Ref: 22/073

4th July 2023

RE: Traffic Addendum 1 – Manufactured Home Estate – Lot 1 DP 304132 – 40 – 80 Chapman’s Road, Tuncurry.

Figure 1 – Development Traffic Trip Distribution

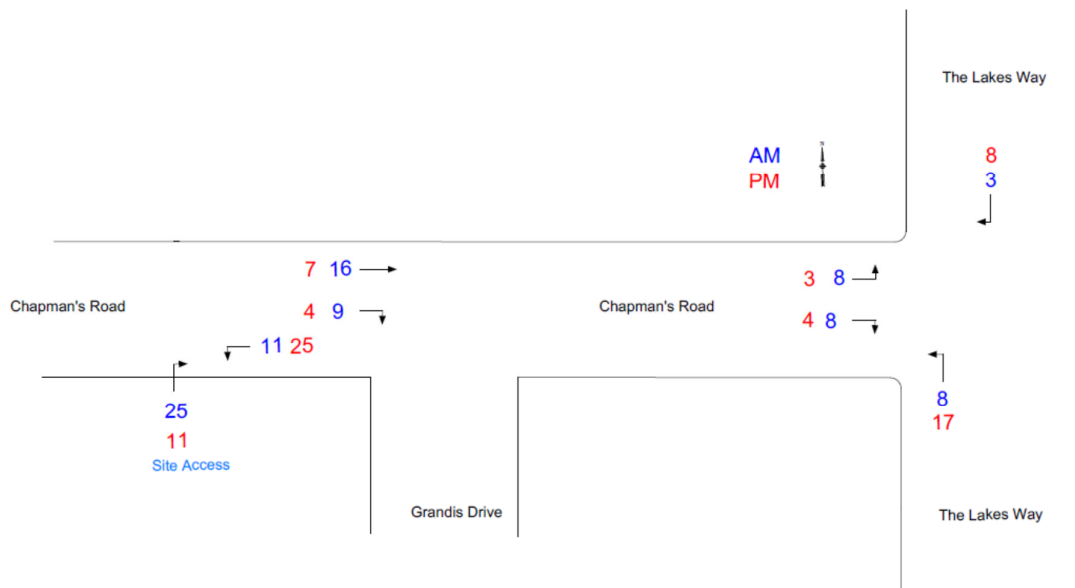
In terms of likely through traffic on Grandis Drive in the AM peak, 30 of 85 vehicles turned right into Grandis Drive (35%) and in the PM peak 18 of 54 vehicles (33%) turned right into Grandis Drive.

Therefore, adopting these percentages to the trip distribution for the development the revised development traffic trip distribution for the development is as shown in **Figure 1** below.

Therefore, the development is likely to result in an additional 9 vph on Grandis Drive in the AM peak and 4 vph on Grandis Drive in the PM peak. This will increase traffic flow on Grandis Drive to a maximum 93 vph in the AM peak and 128 vph in the PM peak which is still well below the environmental capacity of Grandis Drive (300 vph) therefore the development will not adversely impact on Grandis Drive nor on the amenity of residents living on Grandis Drive through the adjoining residential development.

Attachment 1 – Traffic Count Data – Chapmans Road / Grandis Drive Intersection

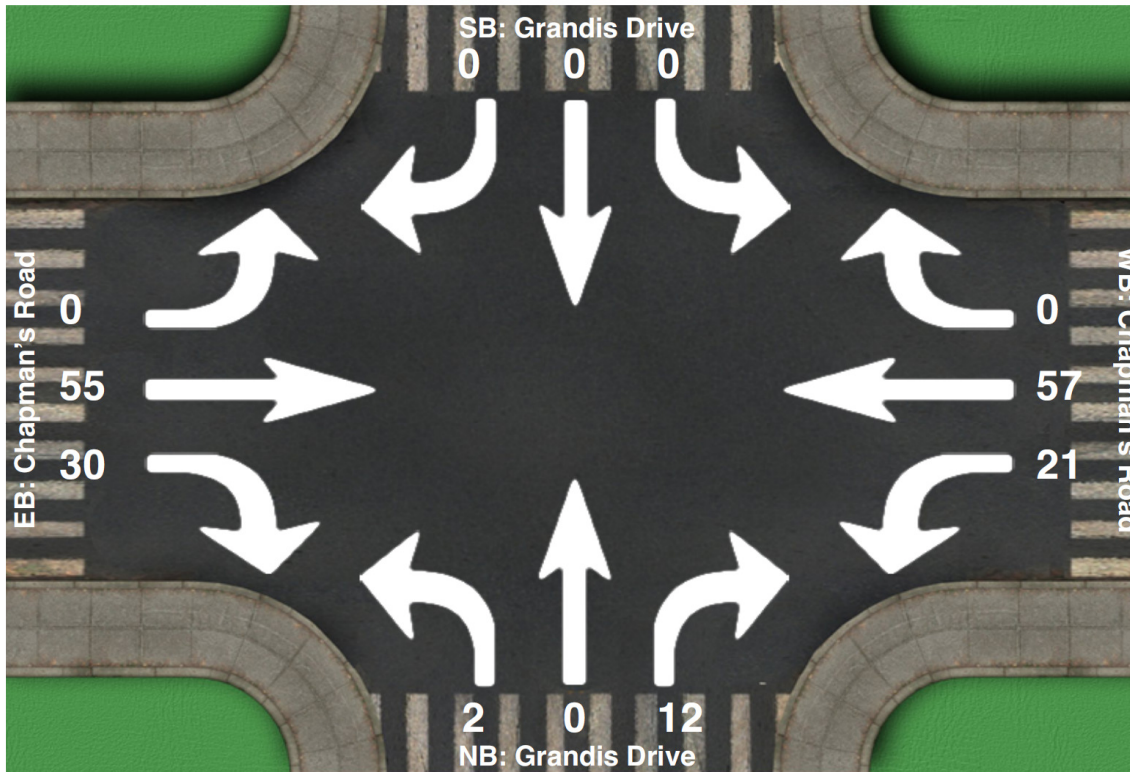
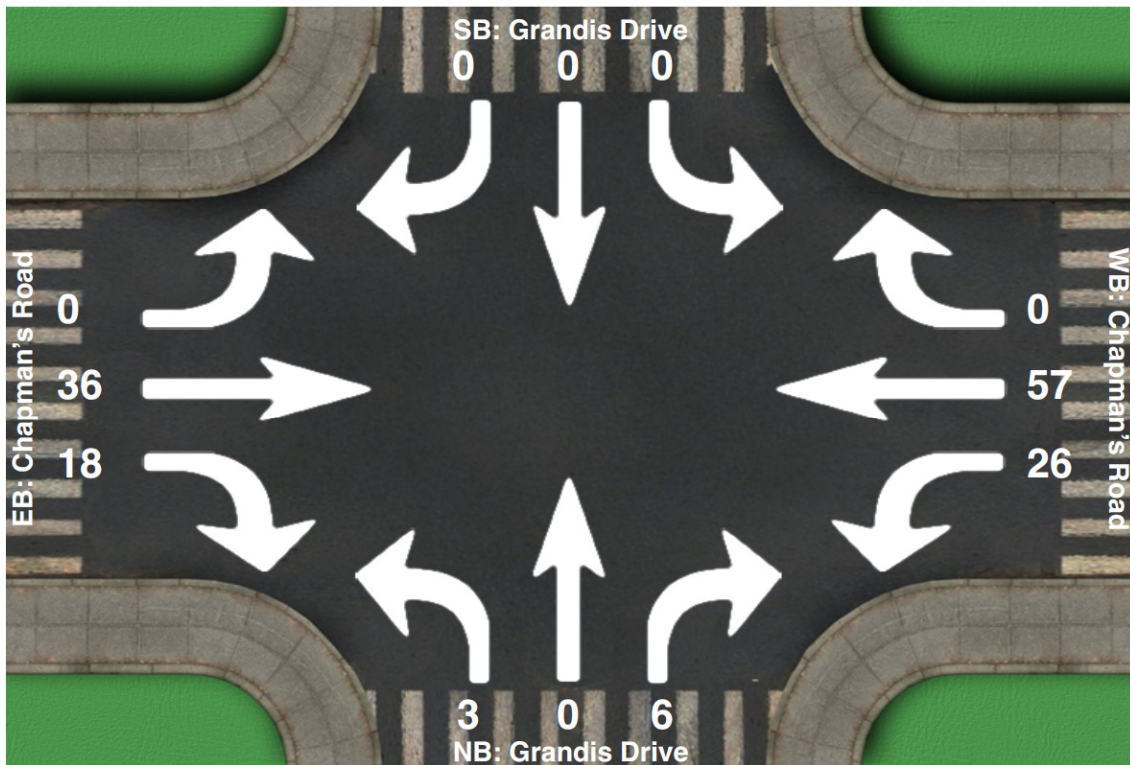
To determine the impact of the development traffic on Grandis Drive, traffic counts were undertaken at the Chapmans Road / Grandis Drive intersection during likely AM and PM peak hour periods. The count results are shown in **Attachment 1** and the relevant data extracted from these counts is as follows.
